UNITED STATES PATENT AND TRADEMARK OFFICE

APPLICATION NO.	FILING DATE	FIRST NAMED INVENTOR	ATTORNEY DOCKET NO.	CONFIRMATION NO.
09/421,625	10/19/1999	EUGENE P. MARSH	M122-1284	4404

Office Action Summary

DETAILED ACTION

FIG. 1A

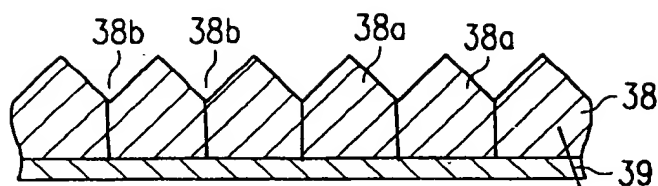
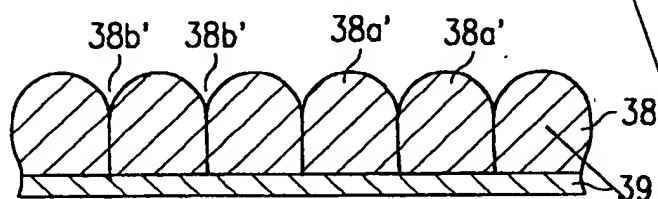
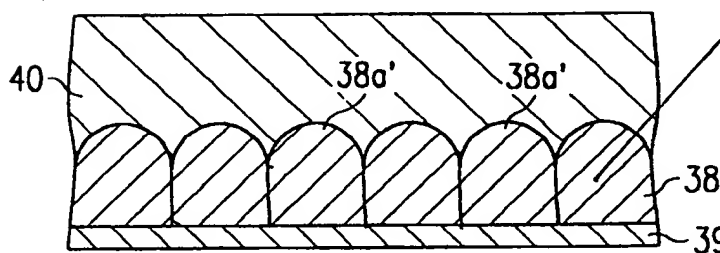
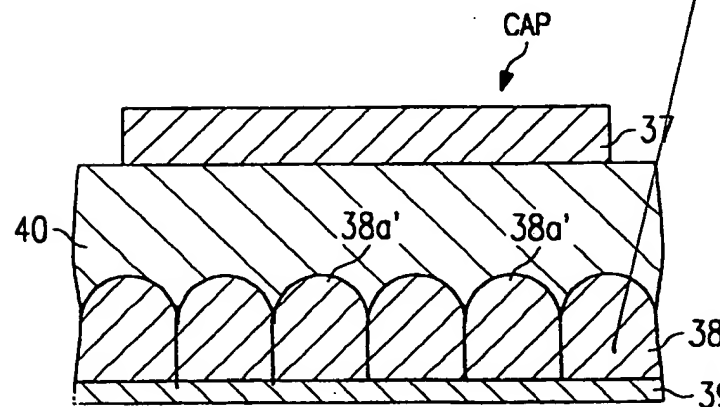
It is argued, at page 7 of the Remarks, that Aoki et al. does not disclose a roughened platinum layer characterized by columnar pedestals. This argument is not convincing because Aoki et al.

shows, in red-mark Figures 1A – 1D, a roughened platinum layer characterized by columnar pedestals. Therefore, Applicants' claims 65 and 74 do not distinguish over the Aoki et al. reference.

Columnar pedestals
